The Commission has issued the enclosed Amendments Nos. ⁴² and ¹¹ to Facility Operating Licenses Nos. DPR-51 and NPF-6 for Arkansas Nuclear One, Units Nos. 1 and 2 (ANO-1&2). The amendments consist of changes to the Technical Specifications in response to your application dated February 12, 1979.

The amendments modify the ANO-1&2 Appendices A and B Technical Specifications dealing with Arkansas Power and Light Company management organization structure.

SAFETY EVALUATION BY THE OFFICE OF NUCLEAR REACTOR REGULATION

SUPPORTING AMENDMENTS NOS. 42 AND 11 TO

Figure 6.2-1 Management Organization Chart

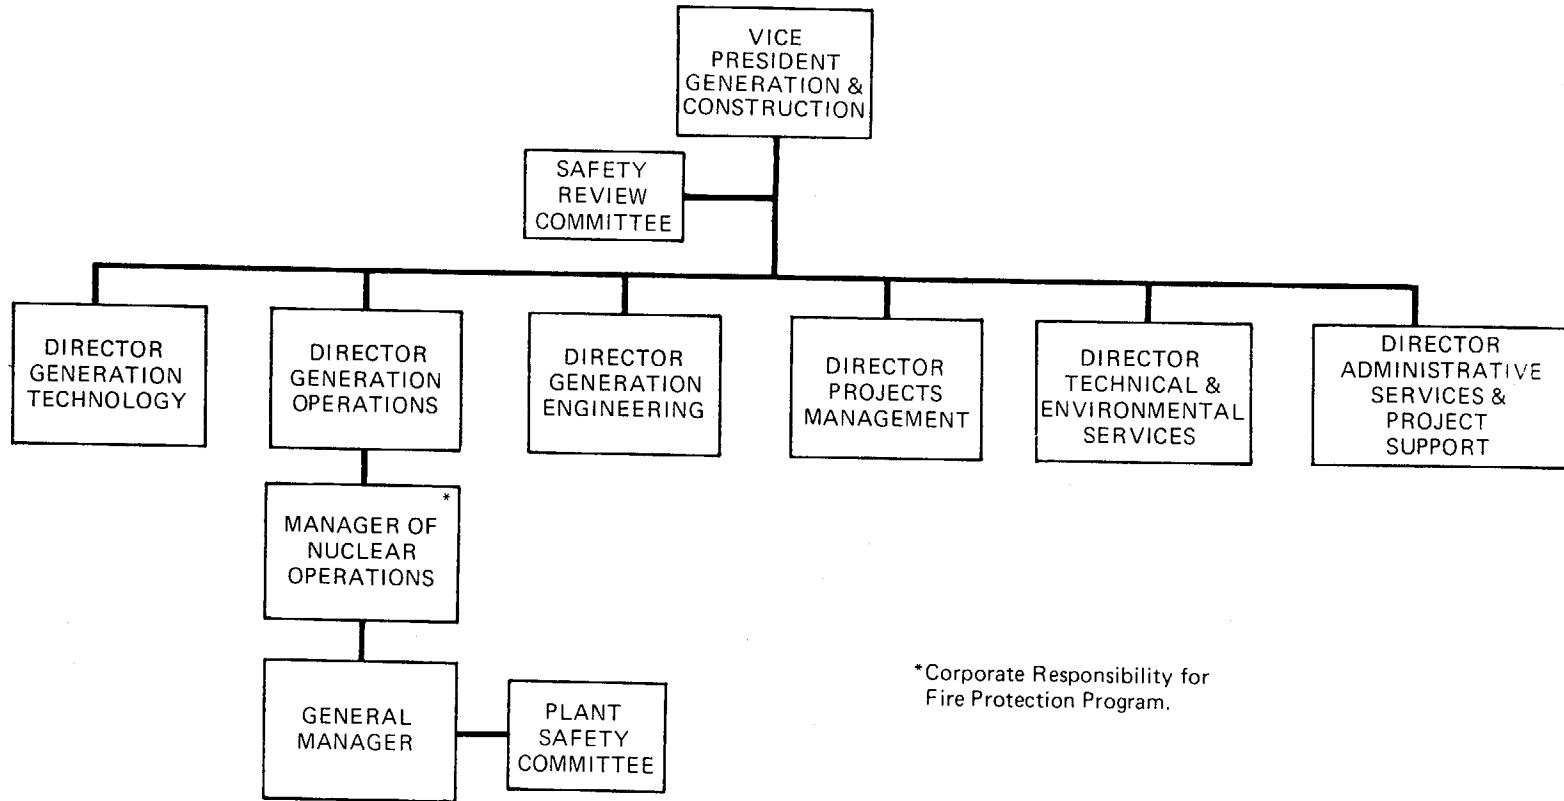
We have reviewed the proposed change to the ANO-1&2 Administrative Control Sections of the TS. The Executive Director, Generation and Construction, would be changed to Vice President, Generation and Construction. The functions and responsibilities of the new position are the same as those of the Executive Director, Generation and Construction.

FIG. NO.
5-1

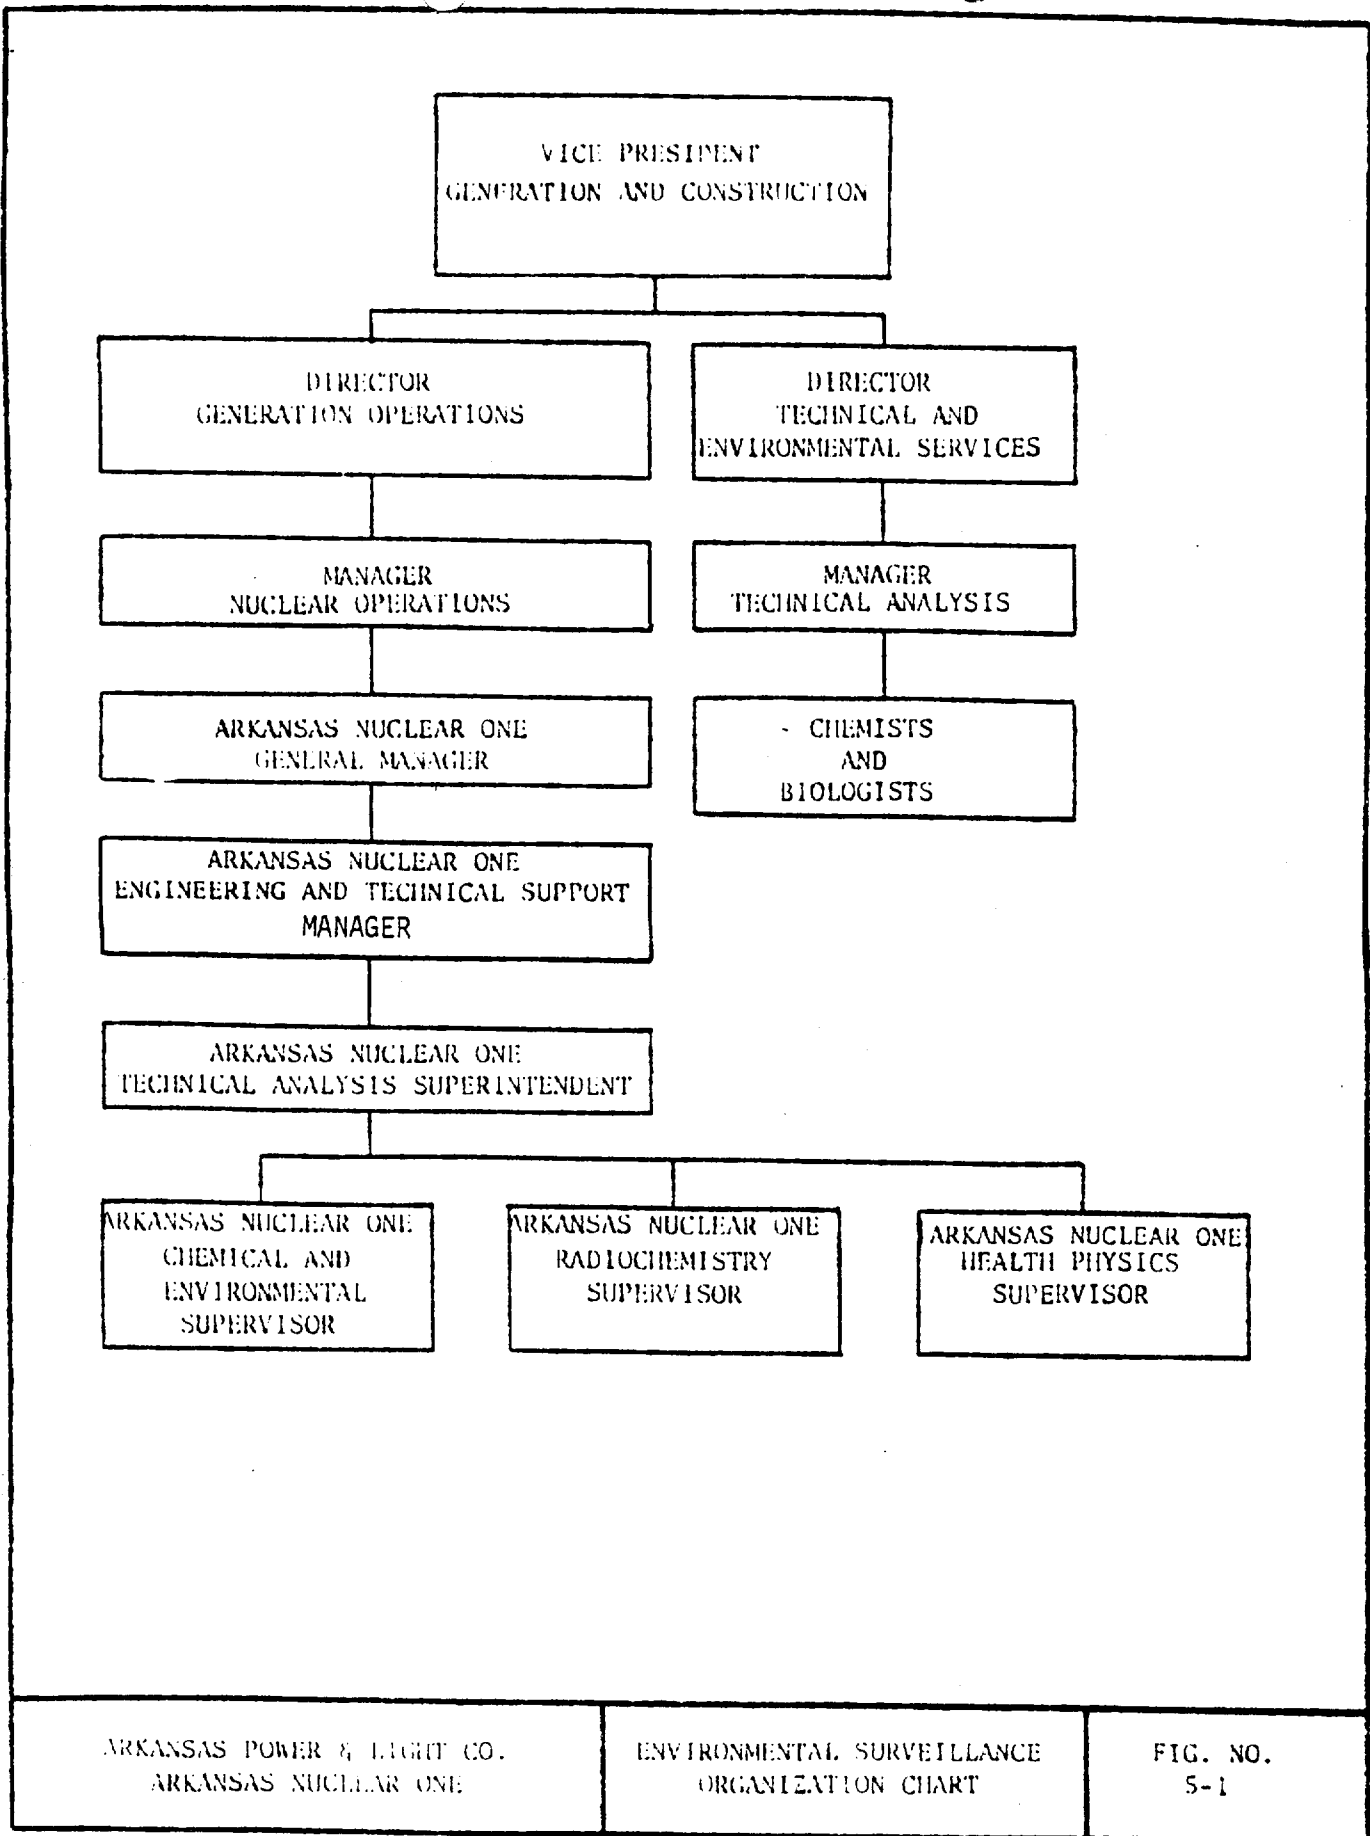
Figure 5-1 shows the organization chart at both plant and corporate levels relative to environmental matters.

FIG. NO.
5-1

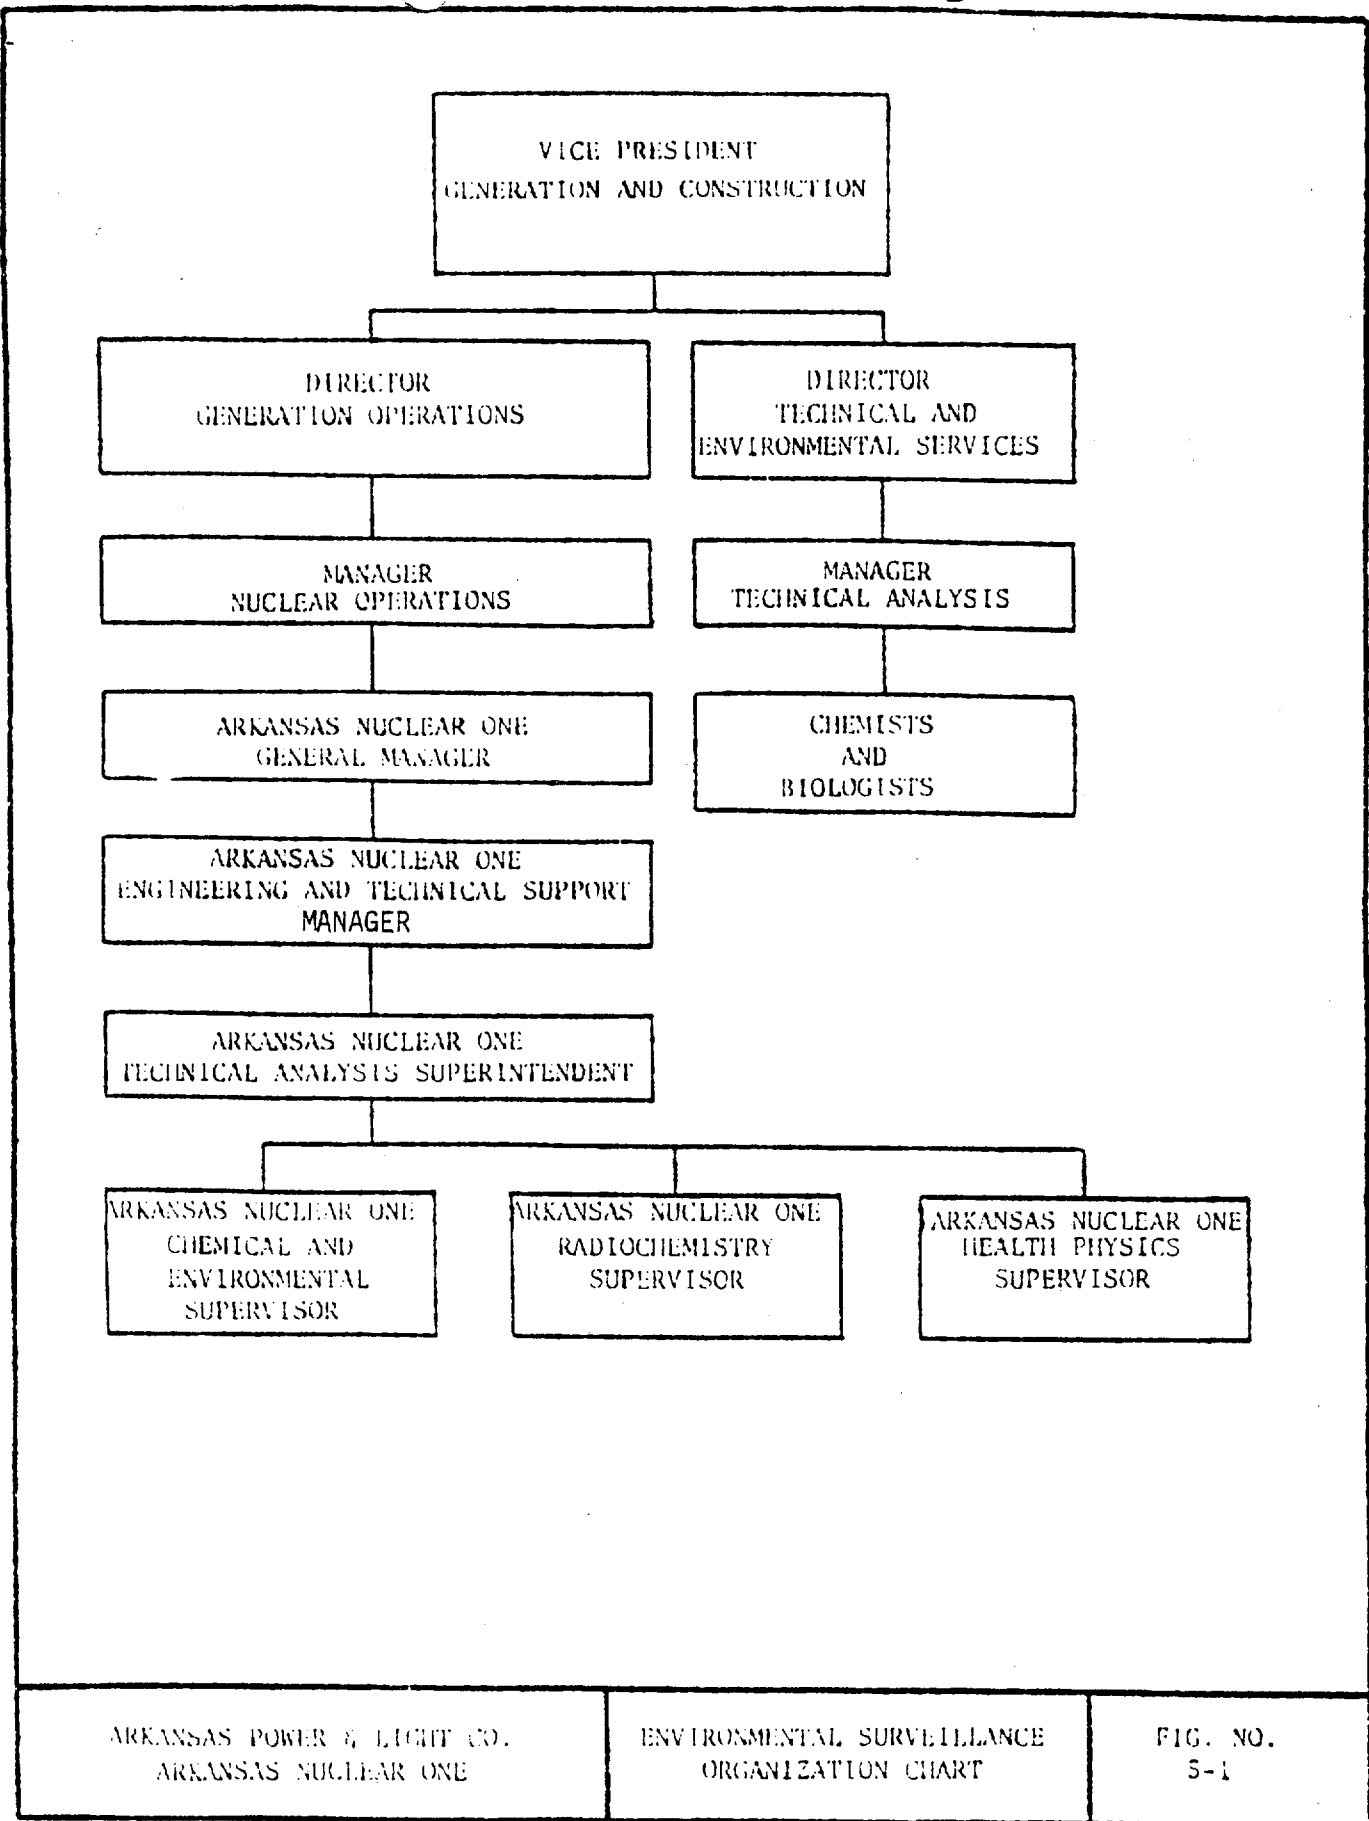
Figure 5-1 shows the organization chart at both plant and corporate levels relative to environmental matters.
